TRANSWESTERN PIPELINE COMPANY
An ENERGY TRANSFER Company

October 14, 2021

RE: Approval with Modifications
Report of 2020 Groundwater Remediation Activities
Roswell Compressor Station No. 9
Transwestern Pipeline Company
Roswell, Chaves County, New Mexico
NMOCD Abatement Plan #AP-125 (formerly #GW-052)
EPA ID No. NMD986676955
HWB-TWP-21-001

MPE-20 Borehole Illustration

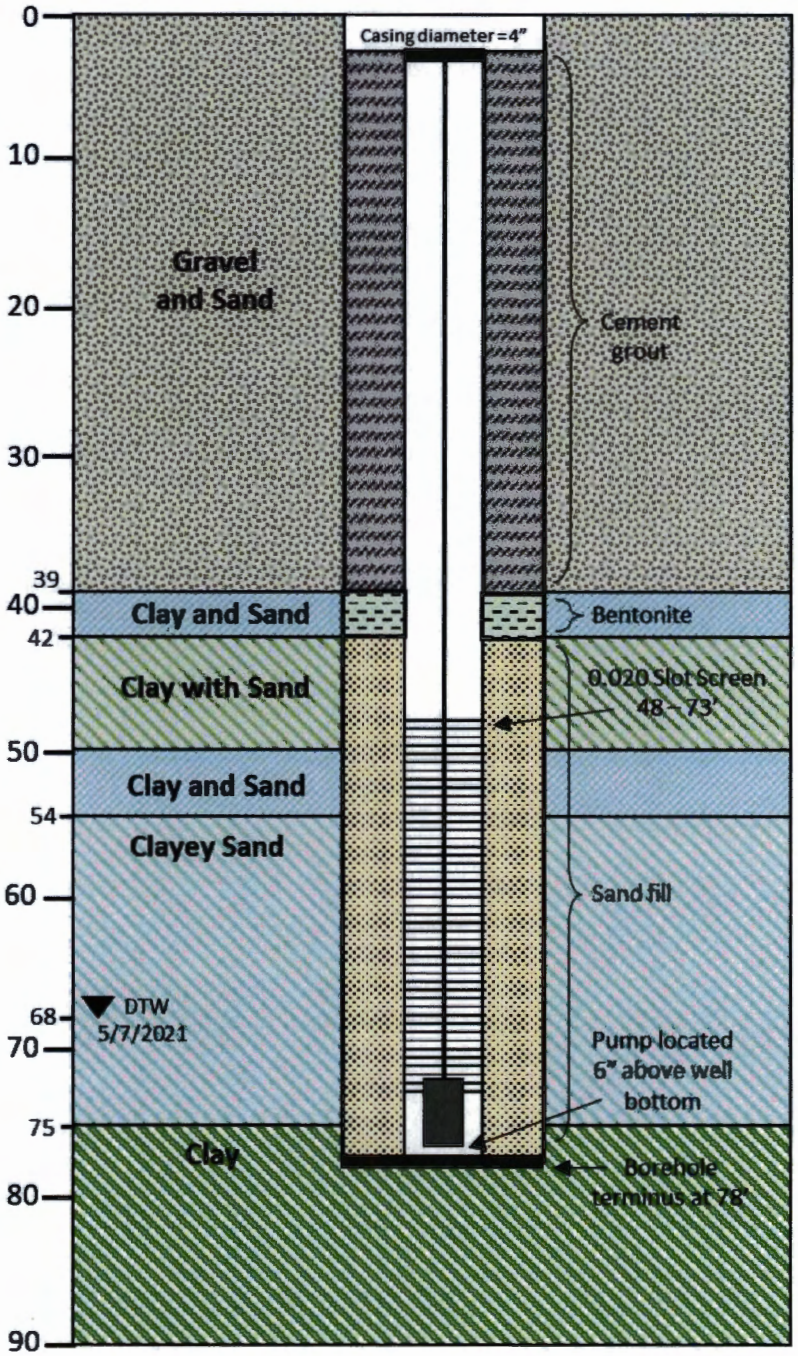
In Section 4.2, *Groundwater Treatment System Monitoring Results,* page 12, the Respondent states, "[t]he MPE wells are installed on top of the clay layer, and the pumps are currently installed 6 inches from the bottom of the wells. Lowering the pumps in the wells is not possible as the clay layer might be penetrated." It is not clear how lowering the pump would penetrate the clay layer because well end cap would prevent the pump from reaching below the clay layer. Provide a clarification in the response letter.

Section 4.2 was updated to: Lowering the pumps in the wells is not possible as the depth of the wells are terminated at the top of the clay layer. Replacement page is attached.

An illustration of MPE 20 is included for reference detailing the location of the top of the clay layer in relation to the well construction to help visually show how lowering the pump would penetrate the clay layer.
